PERCOLATION TESTING

RE: Percolation test results
Purpose: Subdivision
Property ID: Cherry Brae Lots 4-8
Tax Map 41, Parcel 198
Simpson Road

Signed
Revised
Percolation Plat

From: Oswald Jr, Woodin
Sent: Tuesday, July 30, 2024 9:04 AM
To: jim@jnmengineeringllc.com
Subject: Perc Cert Plan_11935 SW Simpson Road

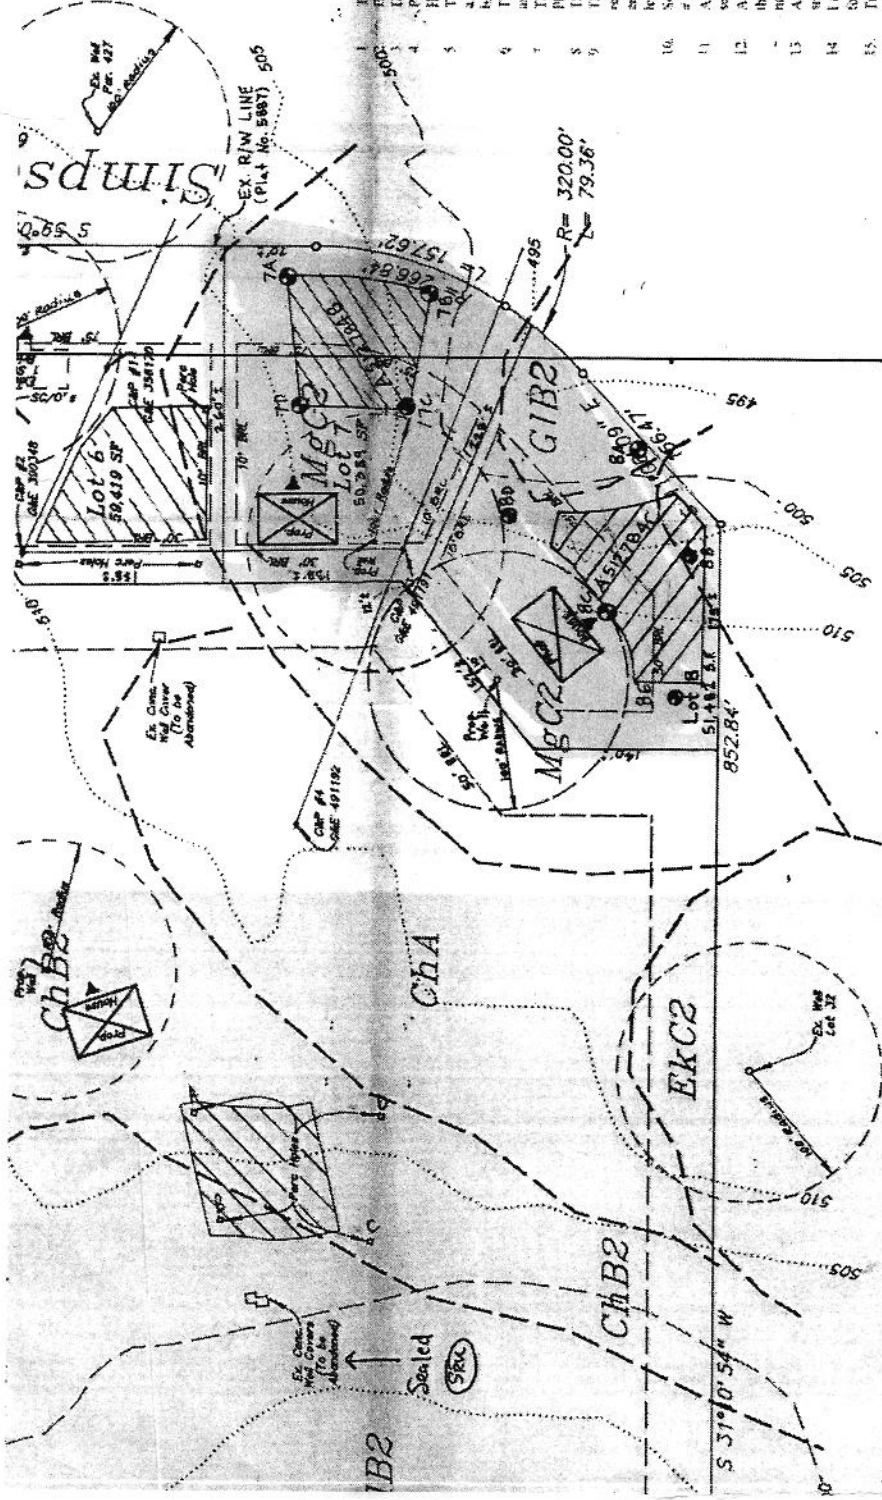
REMARKS use 8D-8B as lowermost bound of SDA -

Revised
Percolation Plat

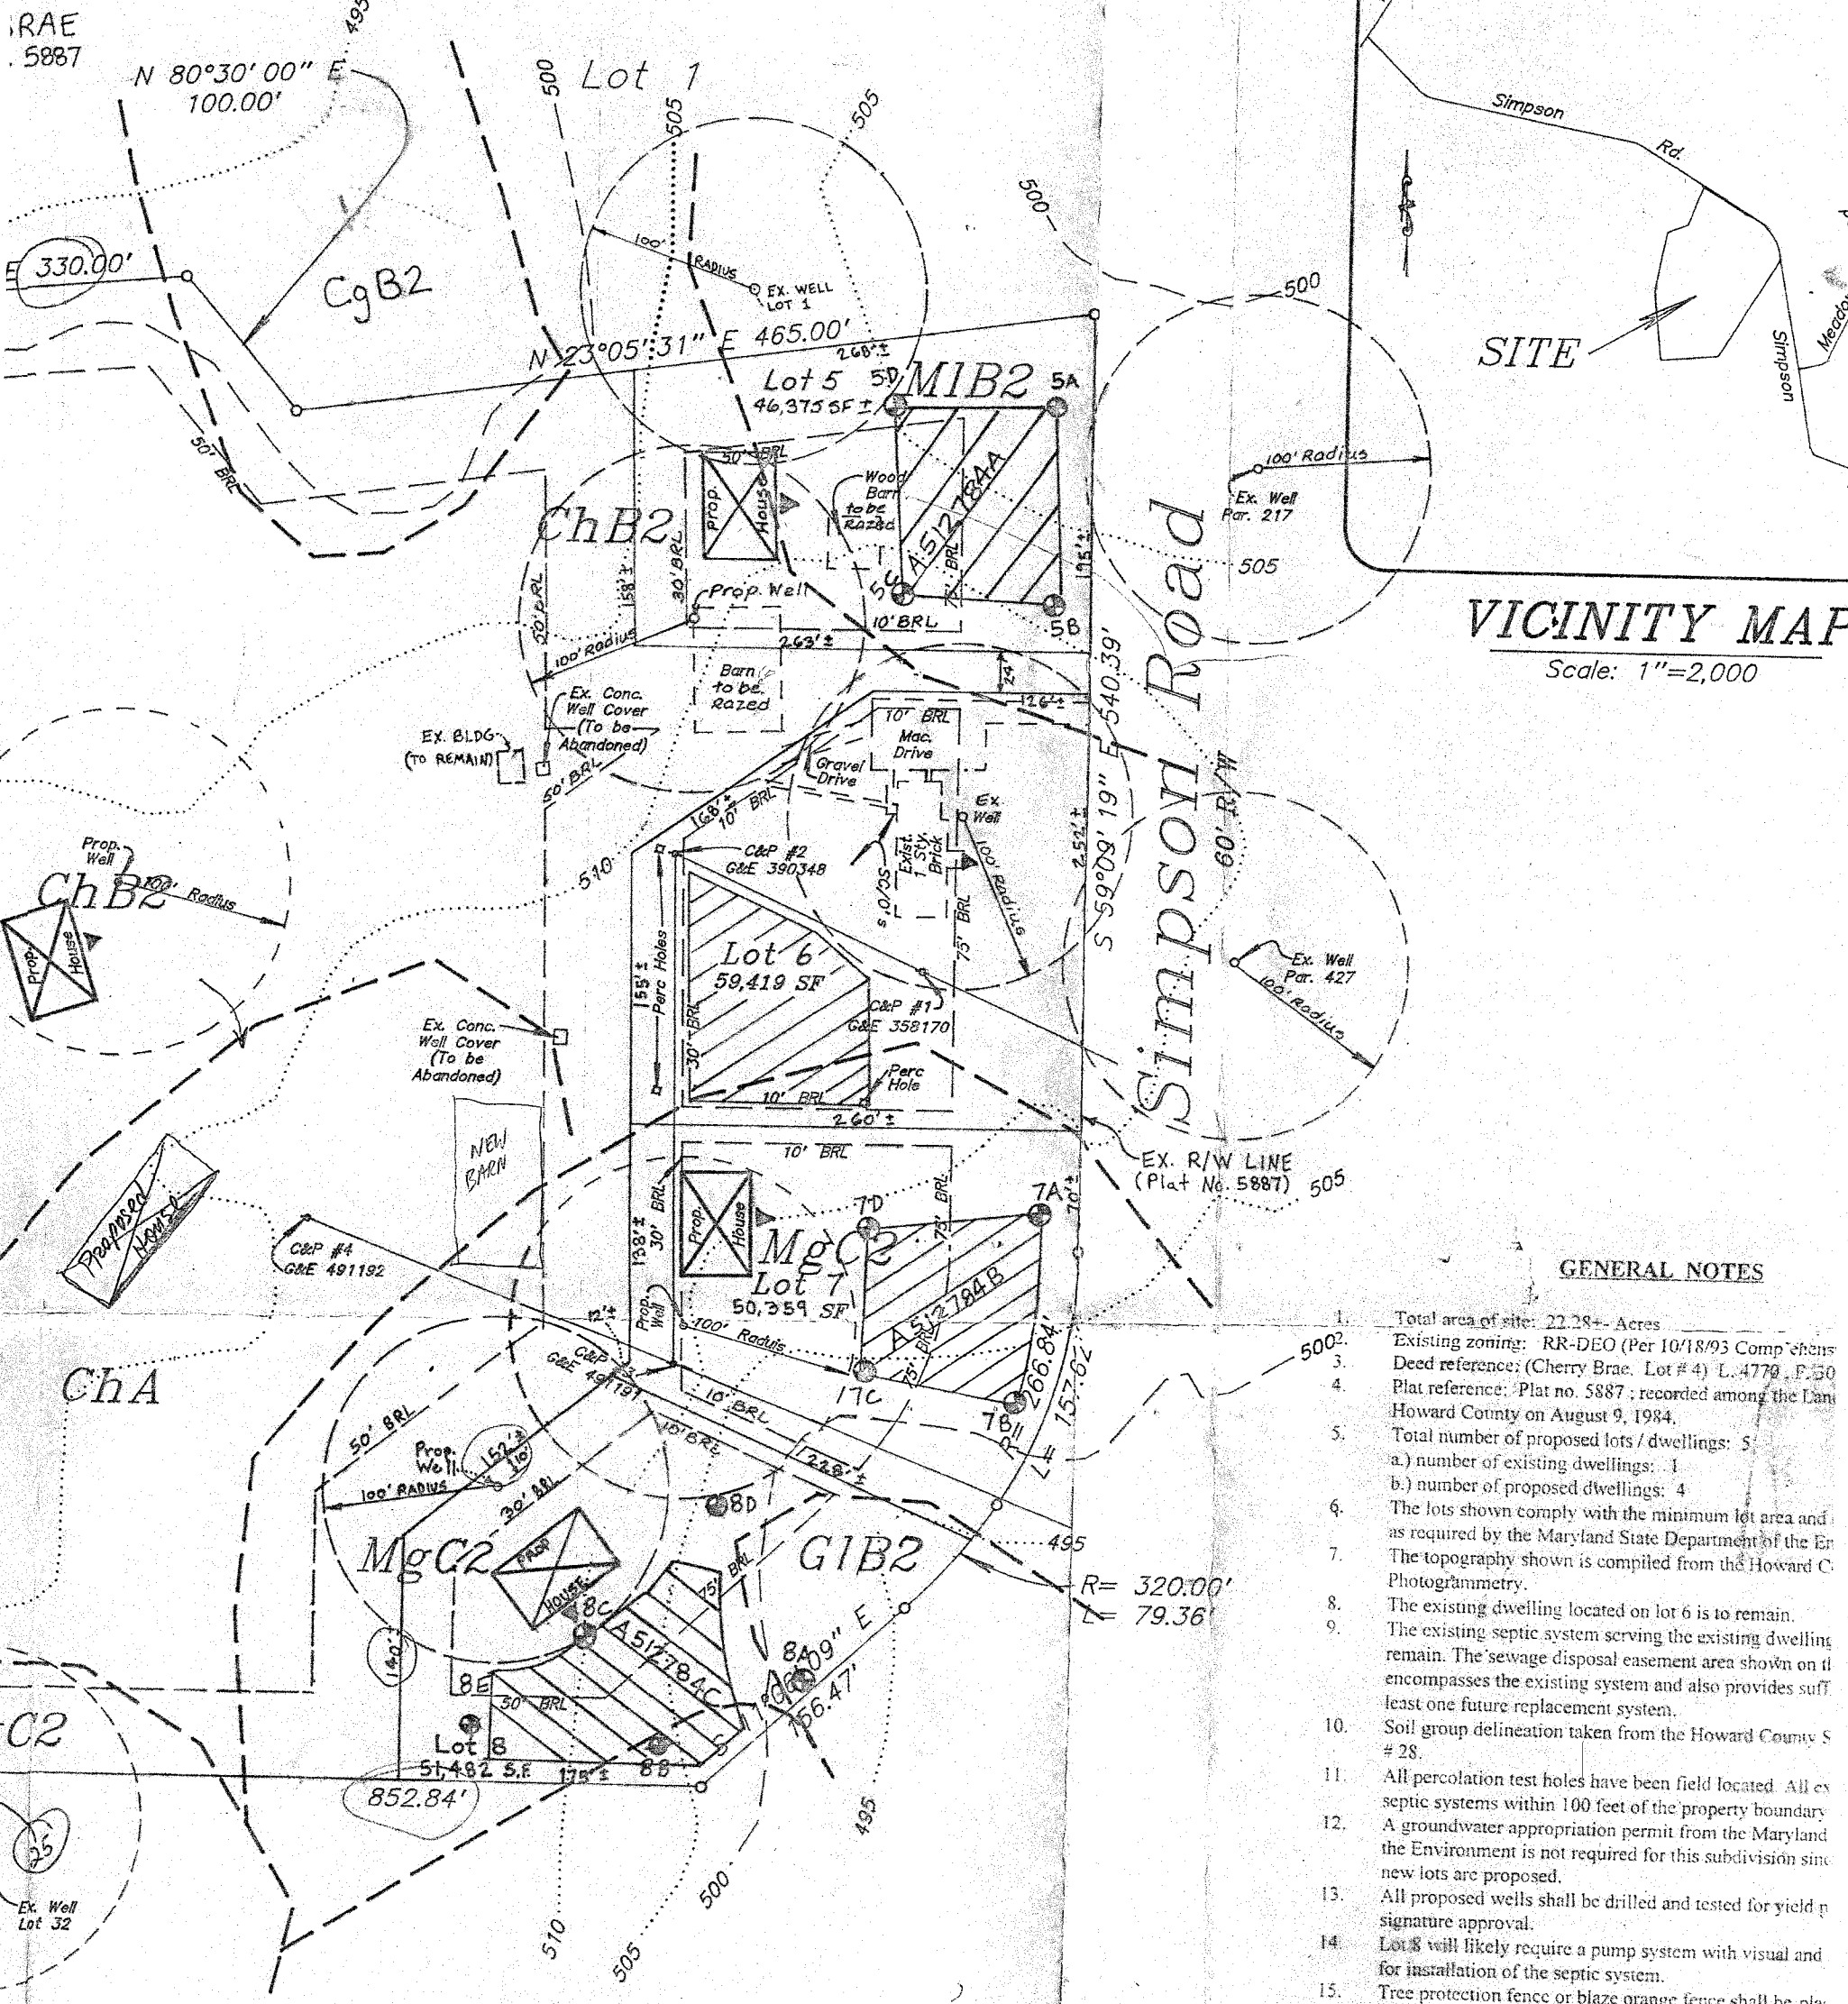
As for Lot 7 (11935 Simpson Road), the homeowner will need to ask for a variance from MDE for the well box on this lot. The well box on Lot 7 is considered downgrade of the SDA located on Lot 6 (11945 Simpson Road). A revised perc cert plan is required to add the well box and adjust the SDA. No additional perc testing is required at this time.

Lot 8 (11915 Simpson Road) - A revised perc cert plan is required to add the alternate well sites and adjust the SDA. No additional perc testing is required at this time.

Any adjustment to the SDA on **11915 Simpson Road, Lot 8** will require a revised perc cert plan. Additional perc testing may be required depending on the changes.

Lot 8- The existing well is within 100-feet of the approved septic area as shown on the plat. The septic area is 11,321sf and could be shortened where the well arcs encroach and expanded downgrade and we would still be able to get a minimum 10,000sf. We would also adjust to avoid the alternate well locations and the well box for lot 7. Given this, would we be required to add perc locations or would we just have to submit a revised perc certification plan. I have include the approximate perc locations and the results on the plans for reference.

Hank, based on our discussions we have adjusted the SDA from the approved plat (shown in red on attached). We will still have the min. 10,000sf and will be within the boundary of the previously approved perc locations. The purpose of

moving the SDA is to allow more room for a well box and to also allow sufficient room for a house while meeting the 30' well setback and 20' septic setback. I wanted to see if this would be okay for just a new perc certification plan without additional testing. Our goal is to avoid this if we can. If needed, I can swing in for a quick meeting to discuss.
